PZ&B Staff Combination Memorandum: Landmarks Preservation Commission and Town Council

SUBJECT: COA-24-0025 (ZON-24-0065) 70 MIDDLE RD (COMBO)

MEETING: MARCH 19, 2025 LPC
APRIL 9, 2025 TC

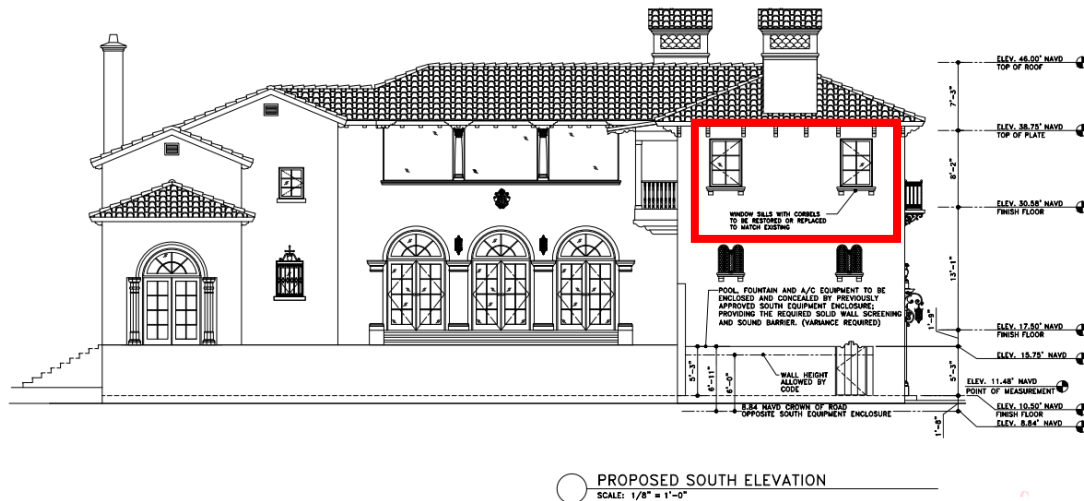
On the east elevation, existing columns adjacent to arched stained-glass windows will be replaced with structural steel columns encased with replicas of the original columns. According to the applicant, the replicas will be created using molds of the original columns. The window sills and front door surround are also proposed to be restored or replaced to match the original. Impact glass has been previously to be installation in front of the stained glass, under an administratively reviewed application. Additionally, barrel tile detailing on the east elevation will be restored or replaced.

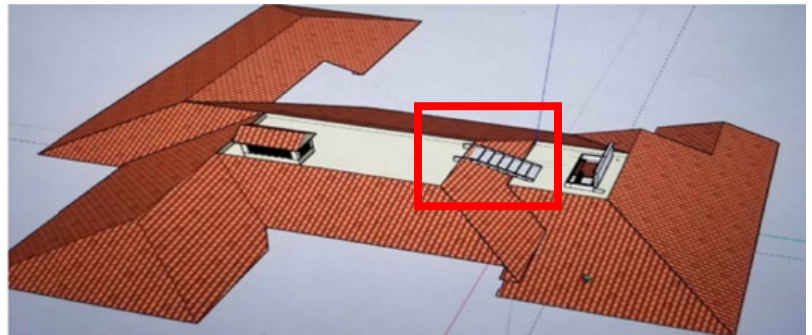
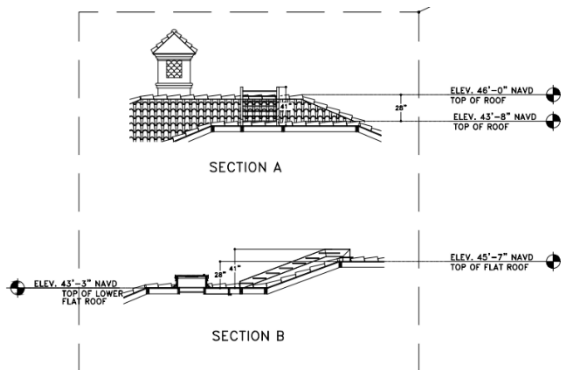
On the south elevation, the window sills are proposed to be restored or replaced to match the original.

The scope of work includes new rooftop aluminum steps. According to the applicant, the steps are needed to ensure the safety of maintenance crew. Since the height of the landmarked structure is non-conforming, the installation of the new steps requires a variance which is further discussed in the variance analysis portion of this memorandum.

NORTH ELEVATION

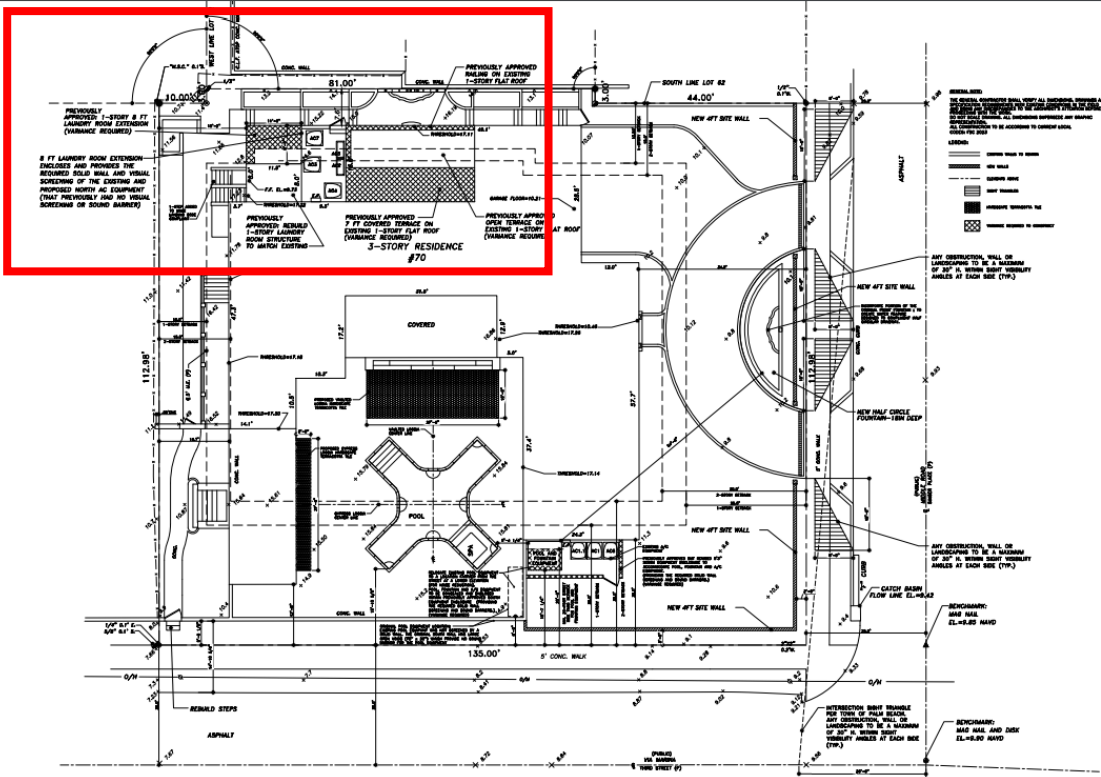
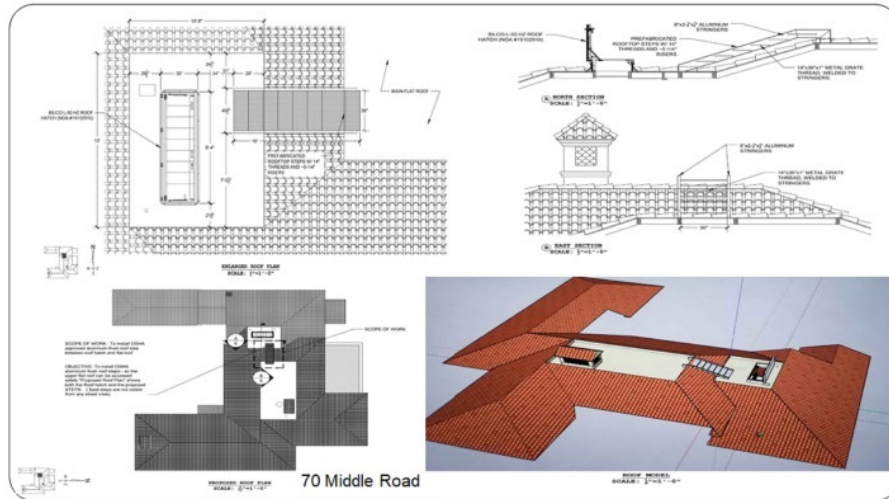
- Variance #4** increases the building height of the covered terrace addition to 27.4', surpassing the 22' maximum allowed, as well as increasing the rooftop steps to 47.1', exceeding both the existing overall building height of 46' and the 30' maximum permitted.

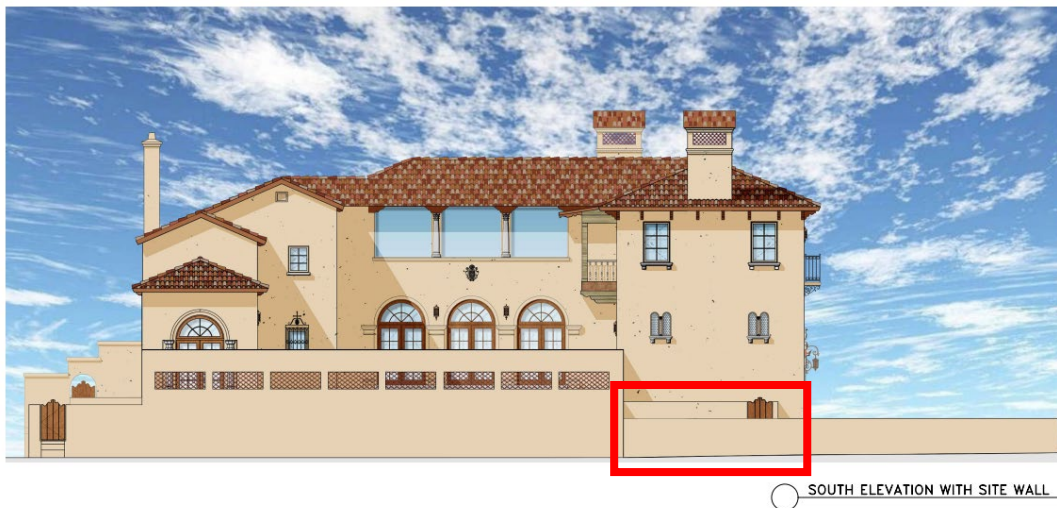
- **Variance #5** reduces the street (south) side yard setback for the pool and fountain equipment to 15.6', rather than the required 20', while also increasing the allowable distance between the new fountain's water edge and the fountain equipment to 54.5', beyond the 25' maximum permitted.
- **Variance #6** increases the height of site walls associated with a mechanical equipment enclosure in the street (south) side yard setback to 6.9', exceeding the allowed maximum of 6'
